HISTORIC AND DESIGN REVIEW COMMISSION

August 19, 2020

HDRC CASE NO: 2020-256
ADDRESS: 515, 517, 519 N PALMETTO
LEGAL DESCRIPTION: NCB 1371 BLK 3 LOT 33 34 & 35
ZONING: RM-4, H
CITY COUNCIL DIST.: 2
DISTRICT: Dignowity Hill Historic District
APPLICANT: ricardo mccullough
OWNER: monica naves/VERGEL CONSTRUCTION LLC
TYPE OF WORK: Construction of three, 1-story residential structures
APPLICATION RECEIVED: July 31, 2020
60-DAY REVIEW: Not applicable due to City Council Emergency Orders
CASE MANAGER: Edward Hall

The applicant is requesting a Certificate of Appropriateness for approval to construct three, 1-story residential structures on the vacant lot at 515 N Palmetto, located within the Dignowity Hill Historic District.

CONCEPTUAL FRONT ELEVATIONS

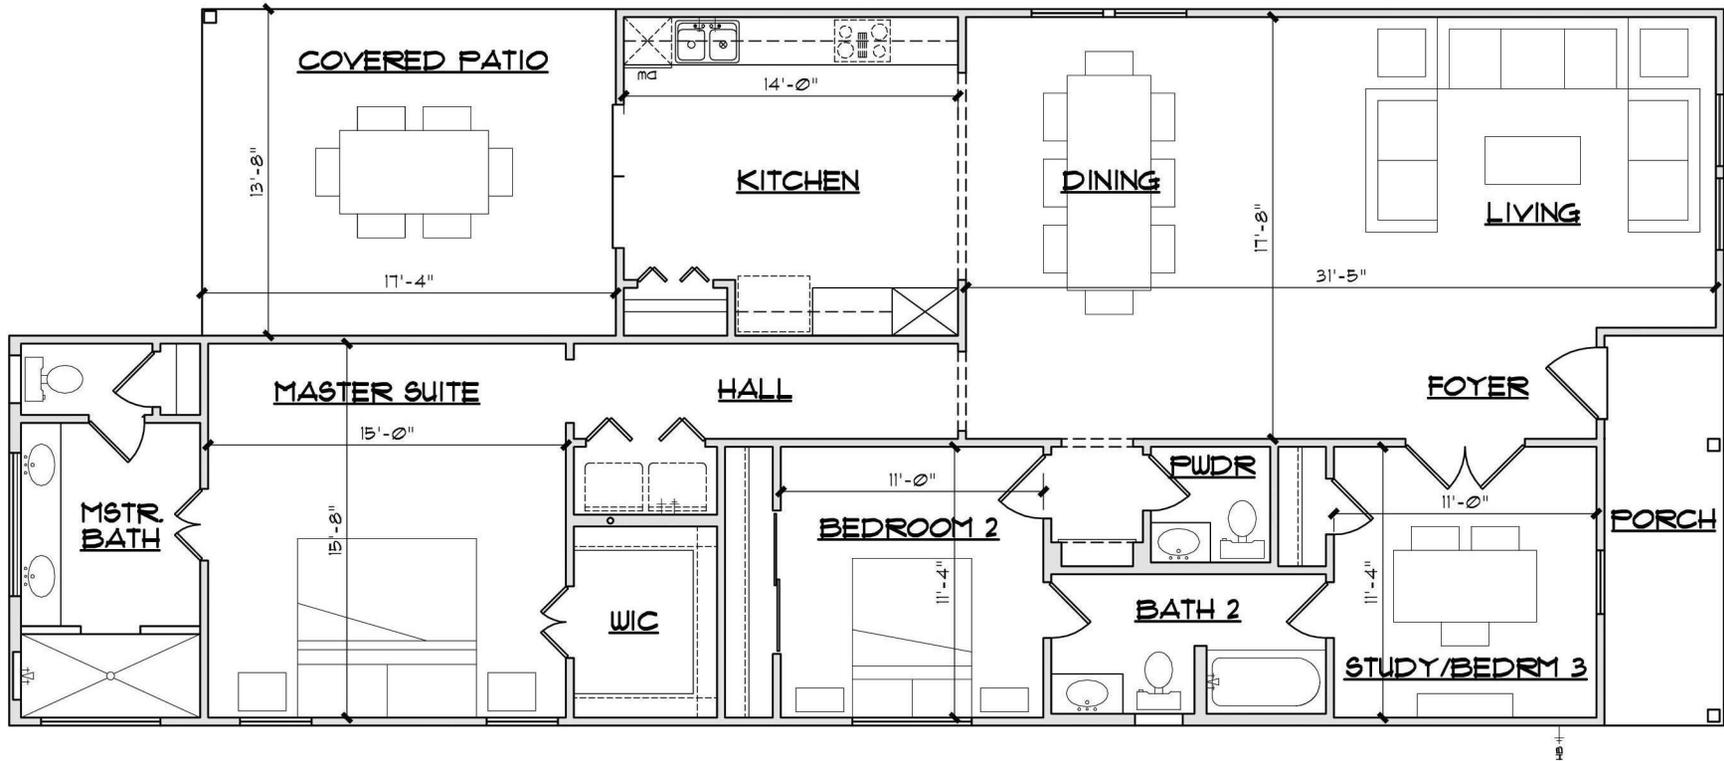
- iii. That each porch feature a depth of at least five (5) feet in depth, and feature a side facing window. **Per the submitted construction documents, this stipulation has not been met.**

in new construction, as noted in finding m. Additionally, gable returns should be eliminated from the gabled roofs. **Per the submitted construction documents, this stipulation has not been met.**

- i. **ROOF FORMS** – The applicant has proposed for each of the three structures to feature gabled and hipped roofs. Staff finds each of these roof forms to be appropriate; however, staff finds that gable returns should be eliminated from gabled roofs.

- k. **PORCH MASSING** – The applicant has proposed for each porch to feature a massing that is incorporated within the massing of each structure. Staff finds this to be appropriate; however, staff finds that each porch should feature a depth of at least five (5) feet. Additionally, staff finds that a side window should be incorporated into the each porch wall (facing the side wall), consistent with historic examples found throughout the district.

- iii. That each porch feature a depth of at least five (5) feet in depth, and feature a side facing window as noted j.
- iv. That all siding feature a four (4) inch exposure, a thickness of ¾”, mitered corners and a smooth finish. Columns should be six inches square, and window materials should meet staff’s standards for windows in new construction, as noted in finding m. Additionally, gable returns should be eliminated from the gabled roofs.

SITE PLAN
SCALE: 1/16" = 1'-0"

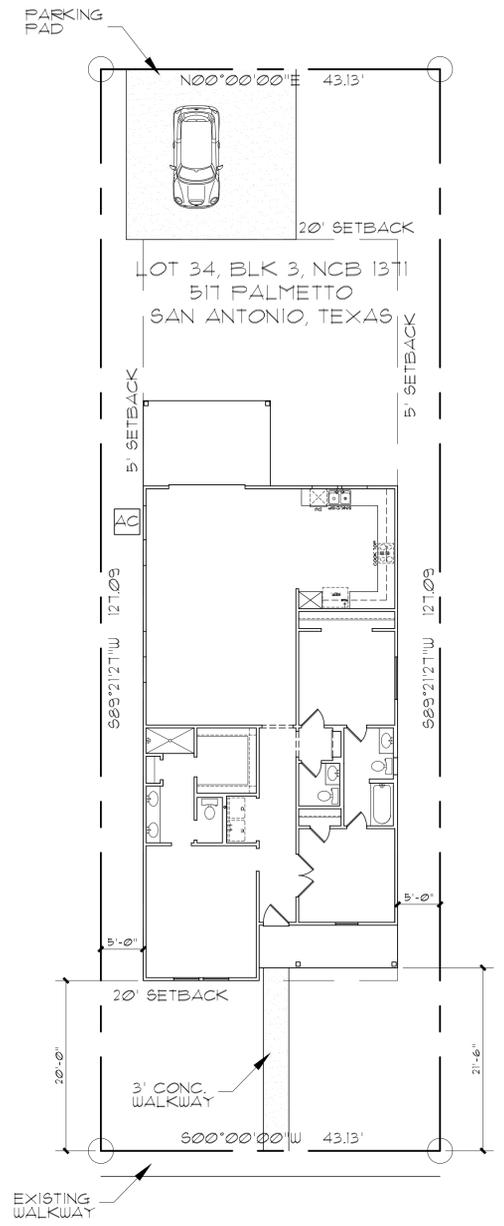
- e. **SITE PLAN** – At this time, the applicant has not submitted an updated site plan noting correct driveway locations. Staff finds that an updated site plan should be submitted to staff prior to a recommendation for final approval.

- r. WALKWAY – The applicant has noted the installation of walkways within the front yard of each residential structure. This is appropriate; however, these walkways should connect to the sidewalk at the right of way.

- t. MECHANICAL EQUIPMENT – The applicant has noted the locations of mechanical equipment at each structure; however, has not noted if the mechanical equipment will be screened. All mechanical equipment should be screened from view at the public right of way with screening elements.

- v. That the applicant install windows that are consistent with staff’s specifications for windows in new construction, as noted in finding m.
- vi. That the applicant develop a landscaping plan and screen all mechanical equipment as noted in findings r and s.

FRONT ELEVATION
SCALE: 1/4" = 1'-0"

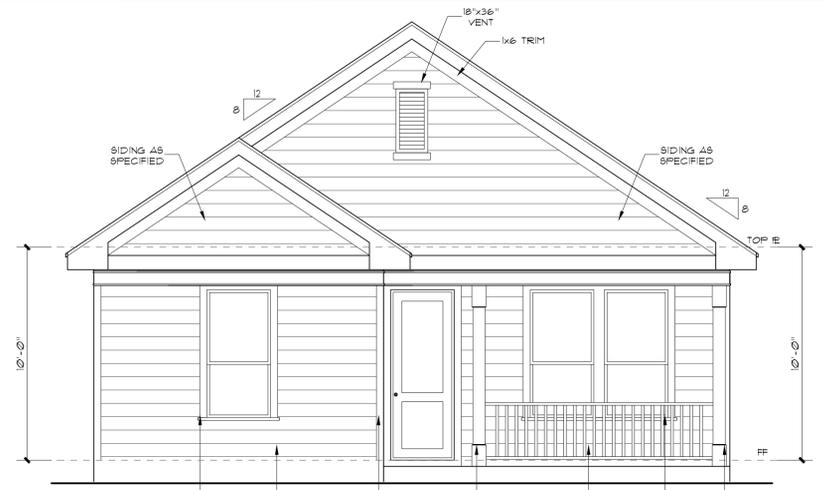
- i. That the applicant utilize foundation heights that are consistent with the Guidelines, at least one (1) foot in height. **Per the submitted construction documents, this stipulation has not been met.**

- h. **FOUNDATION & FLOOR HEIGHTS** – Per the Guidelines for New Construction 2.A.iii., applicants should align foundation and floor-to-floor heights within one foot of floor-to-floor heights on adjacent historic structures. Per the submitted construction documents, the applicant has proposed foundation heights of less than one foot. Staff finds that the applicant should utilize foundation heights that are consistent with the Guidelines, at least one (1) foot in height.

- j. **WINDOW & DOOR OPENINGS** – Per the Guidelines for New Construction 2.C.i., window and door openings with similar proportions of wall to window space as typical with nearby historic facades should be incorporated into new construction. The applicant has incorporated window openings that are consistent with the Guidelines for the front elevations of each structure; however, the other elevations feature contemporary façade openings and window profiles. Staff finds that traditional window openings should be located on each façade.

- i. That the applicant utilize foundation heights that are consistent with the Guidelines, at least one (1) foot in height as noted in finding g.
- ii. That the applicant incorporate traditionally sized window openings on each façade and incorporate additional window openings on both the north and south facades, as noted in finding i.
